OLD ADMINISTRATION BUILDING DEMOLITION

RICHLAND SCHOOL DISTRICT NO. 400
RICHLAND, WASHINGTON

ADDENDUM NO. 2
December 30, 2020

HM1

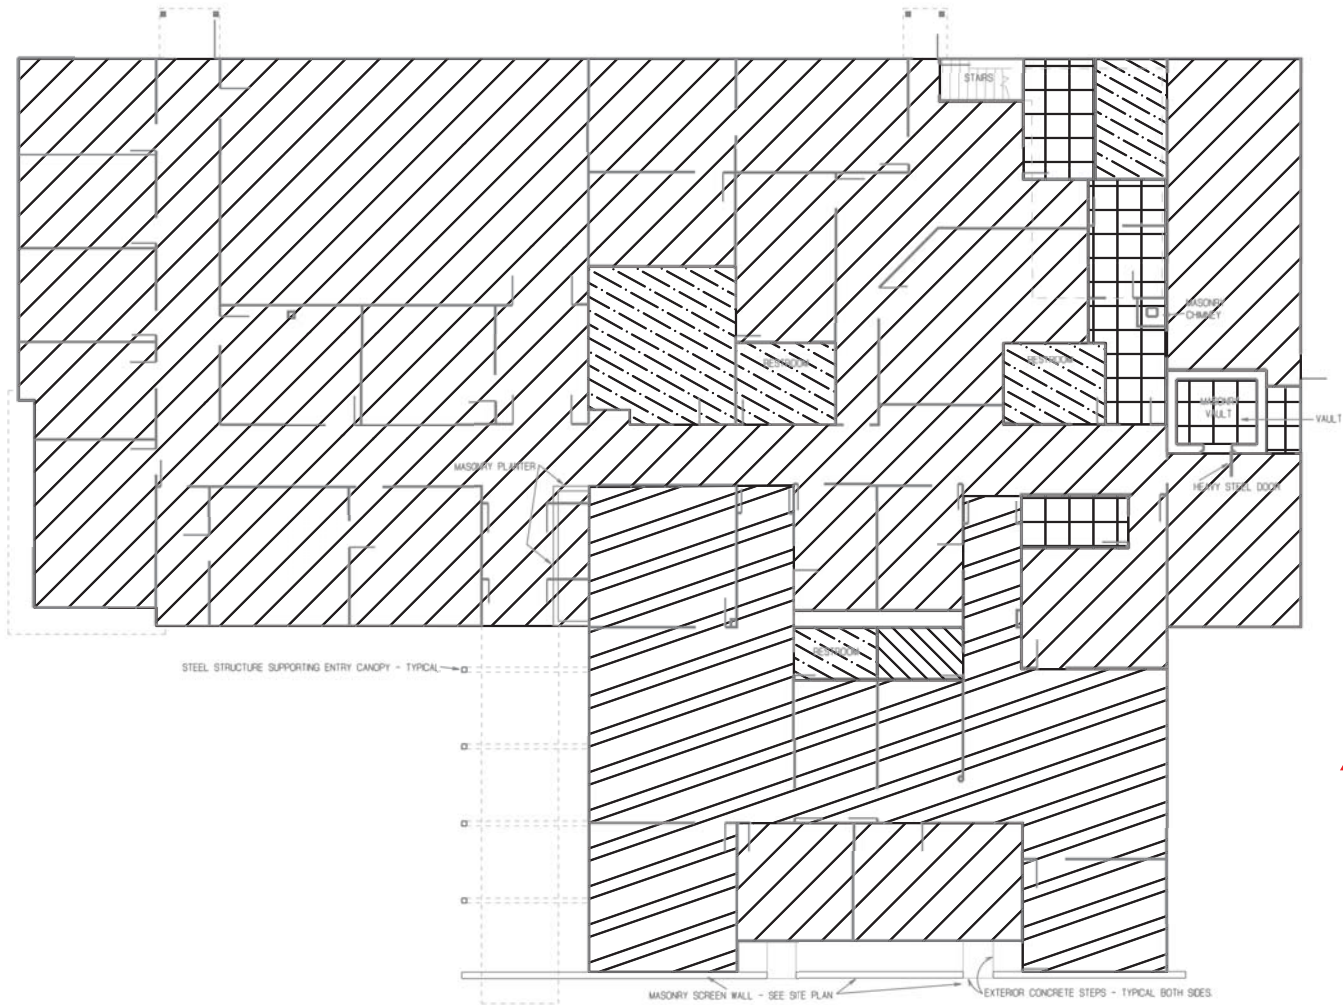
Delete: The HM1 Drawing at the end of this specification section.

Insert: The *revised* HM1 Drawing attached to this addendum.
